Item Name: Crosstube Turning Detail

DART AEROSPACE LTD	Work Order: 77265
Description: Crosstube Assembly (205/212/412 High Fwd)	Part Number: D212-664-141
Inspection Dwg: D212-664-141 Rev: D	Page 1 of 1

DRAWING NO. D212-664-141	TITLE XTUBE ASSY (205/212/412 HI FWD)	REV. D	DART AEROSPACE LTD ENGINEERING ORDER		D.E.O. NO. D212-664-141-D-1	SHEET NO. SHEET 1 OF 2	SCALE NTS
DRAWN	CHECKED	MFG. APPR.	APPROVED	DE APPR.			
DATE 11.04.07	DATE 11.04.11	DATE 11.04.12	DATE 11/04/12	DATE 11.04.12

ADD AN INSPECTION WINDOW TO UNDERSIDE OF CROSSTUBE.

**D212-664-141/-141B
ASSEMBLY DETAIL**

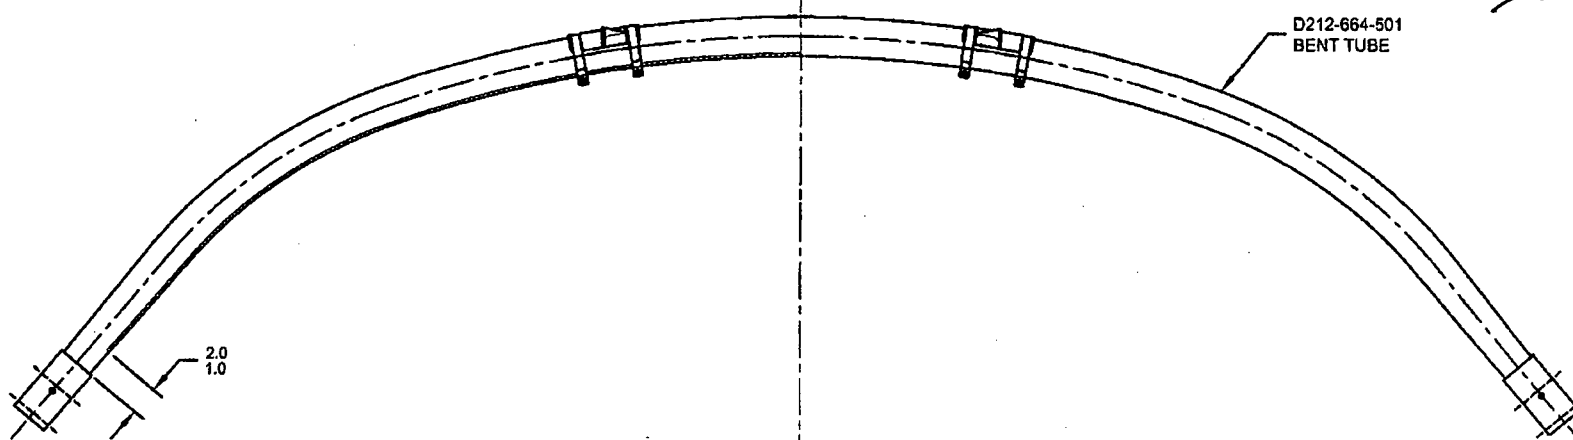
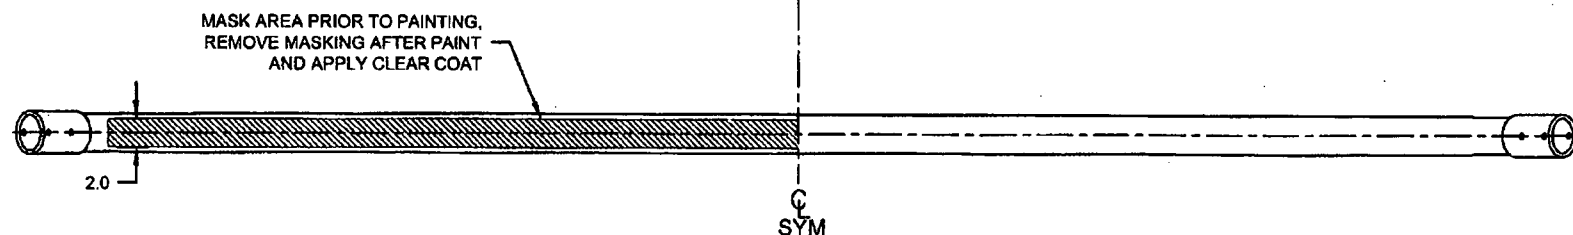
NOTES 2 OF SHEET 1 IS AMENDED AS FOLLOWS:

- 2) FINISH: CHEMICAL CONVERSION COAT PER DART QSI 005 4.1
PRIME INSIDE AND OUTSIDE PER DART QSI 005 4.2
MASK UNDERSIDE OF CROSSTUBE AS SHOWN (HATCHED AREA) AND
PAINT OUTSIDE PER DART QSI 005 4.2
REMOVE MASKING AND APPLY CLEAR COAT

- 2) FINISH: CHEMICAL CONVERSION COAT PER DART QSI 005 4.1
PRIME INSIDE AND OUTSIDE PER DART QSI 005 4.2
PAINT OUTSIDE PER DART QSI 005 4.2
